Access Compliance Report

Public Rights-of-Way

Intersection ID: 12797	Main Street: N_MYERS_ST	Cross Street: E_6TH_ST	Location: N
ADA ID: AA076E63350B	Ramp Type: PerpDiag	Initial Pass/Fail: Fail	Overall Compliance: No
			Severity Score: 21.25

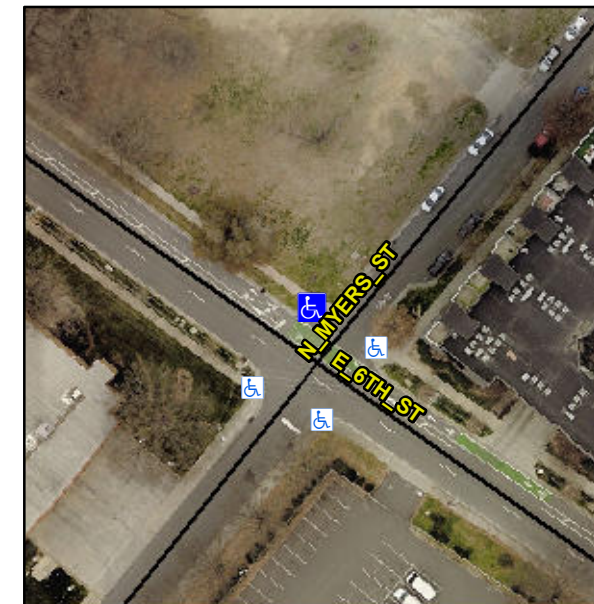
Not Found, R304.5.1, R304.5.3

Compliance	Description	Data	Compliance	Description	Data
N/A	Ramp Length (in)	70.0	Yes	Ramp Slope (%)	6.8
No	Ramp Width (in)	47.5	No	Ramp XSlope (%)	6.5
N/A	Flare Type LT	N/A	N/A	Flare Type RT	N/A
N/A	Flare Slope LT (%)	N/A	N/A	Flare Slope RT (%)	N/A
N/A	Flare Traversable LT?	N/A	N/A	Flare Traversable RT?	N/A
N/A	Landing Length (in)	N/A	N/A	DWS Provided?	N/A
N/A	Landing Width (in)	N/A	N/A	DWS Contrast?	N/A
N/A	Landing Slope (%)	N/A	N/A	DWS Length (in)	N/A
N/A	Landing X Slope (%)	N/A	N/A	DWS Full Width?	N/A
N/A	Landing Curb? (Y/N)	N/A	N/A	DWS Offset (in)	N/A
N/A	Shared Landing?	N/A			
N/A	Gutter Ponding?	N/A	N/A	Gutter Slope (%)	N/A
N/A	Gutter Lip Ht (in)	N/A	N/A	Gutter X Slope (%)	N/A
N/A	Painted X Walk1?	No	N/A	Painted X Walk2?	No
	X Walk 1 Direction	To SW		X Walk 2 Direction	To SE
N/A	X Walk 1 Width (in)	N/A	N/A	X Walk 2 Width (in)	N/A
	X Walk 1 Slope (%)	6.9		X Walk 2 Slope (%)	0.2
	X Walk 1 X Slope (%)	4.4		X Walk 2 X Slope (%)	4.9

Remove & Replace Curb Ramp With Two New Directional Ramps or Equivalent.
